SUBJECT: CERTIFICATION OF THE MINUTES OF THE ACRS
 NUSCALE SUBCOMMITTEE MEETING DECEMBER 18,
 2018, IN ROCKVILLE, MARYLAND

SUBJECT: CERTIFICATION OF THE MINUTES OF THE ACRS NUSCALE
SUBCOMMITTEE MEETING ON DECEMBER 18, 2018, IN
ROCKVILLE, MARYLAND

ADVISORY COMMITTEE ON REACTOR SAFEGUARDS
NUSCALE SUBCOMMITTEE MEETING

Figure 17.4-1: NuScale D-RAP Process for SSC Risk Significance Determination

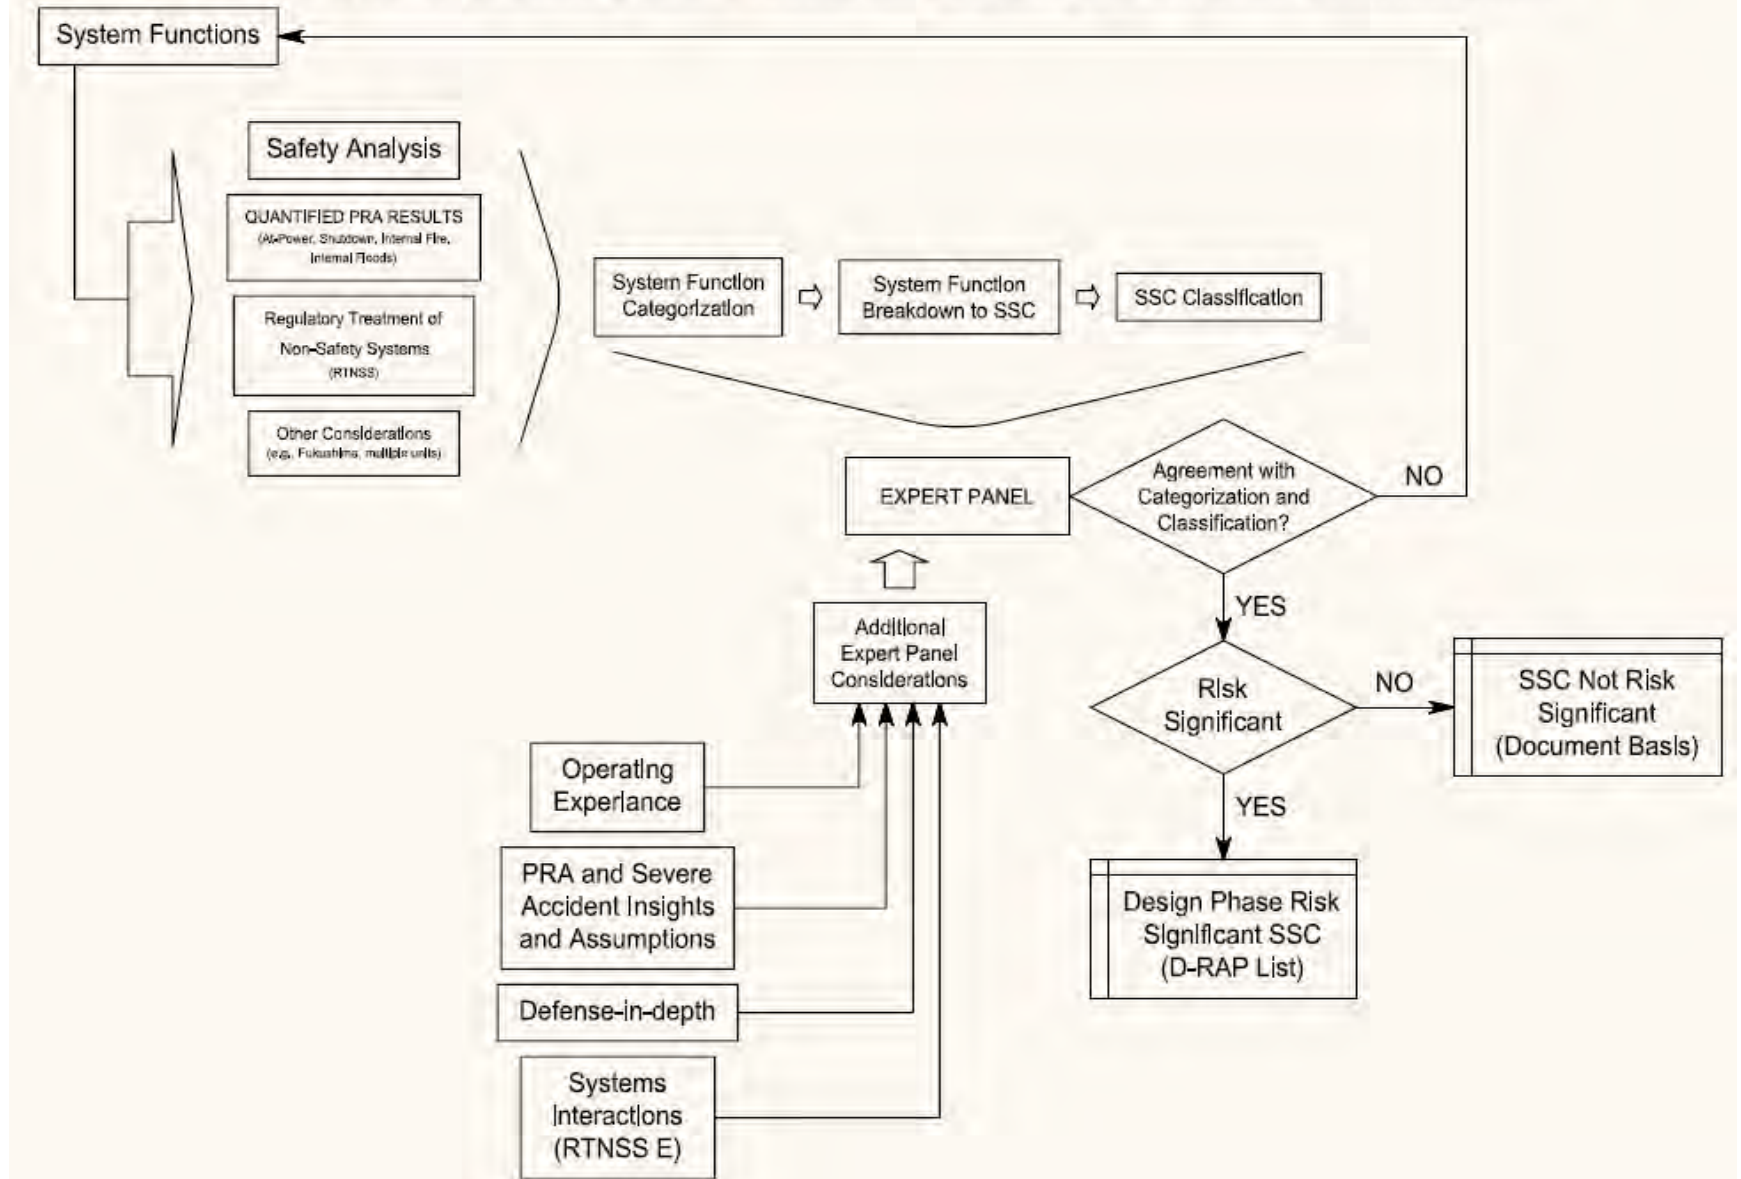
15 What you see here is a figure from the DCA
16 submittal in Chapter 17.4, and this basically outlines
17 the D-RAP process. What I wanted to point out on this
18 slide are a few things here, and it kind of goes back
19 to your question about the program and process itself.
20 We have the safety analysis. We have the results. We
21 look at RTNSS during this process. We also look at
22 other considerations, like Fukushima, other operating
23 experience, what we've learned through our own
24 experiences working with the design. And those will
25 be inputs for the classification that the system

1 the SRP. The staff confirmed that the expert panel
2 considered the appropriate inputs, in addition to the
3 probabilistic information, for the selection of risk-
4 significant SSCs. And the staff reviewed the final
5 list of D-RAP SSCs which are those required to perform
6 risk-significant system functions and verified the
7 process described in FSAR Figure 17.4-1.
